Subject: Geometry

today I committed an update on the beampipe geometry, and I wanted to take a look into what is happening inside the region of the vertex detector (MVD_Rev14b_Corr+Dead.geo):

1) vertex.JPG, downloaded 2394 times

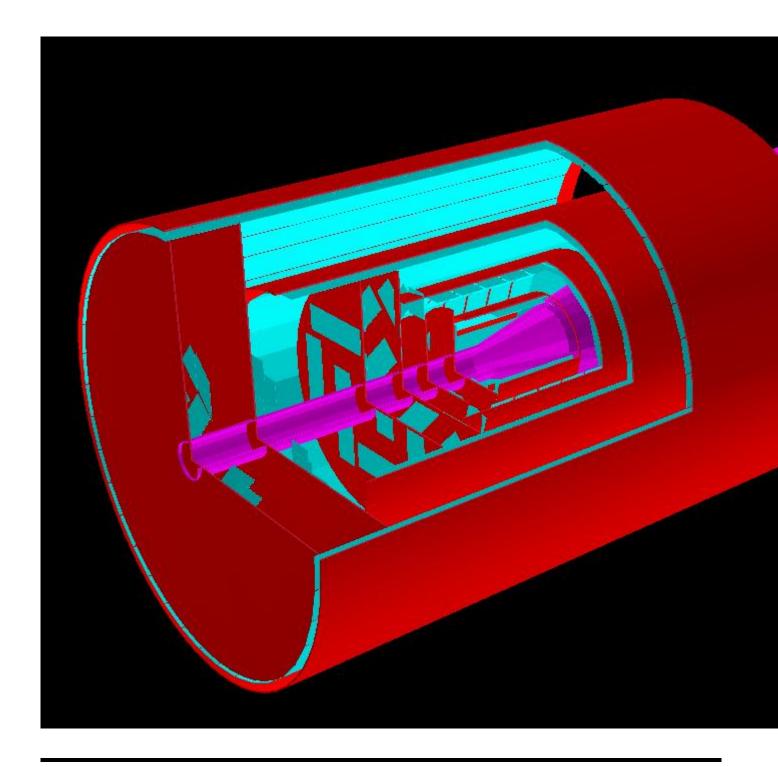
It seems that the forward disks (I think the dead layers) are completely full, and there is no space for the beampipe -> there is overlap between volumes.

I don't know exactly how the geometry will look like, but is it possible to open one hole so that at least we do not have overlap there?

Tobias has an updated geometry from the CAD files, with a detailed support structure and cooling. However the implementation is not ready yet.
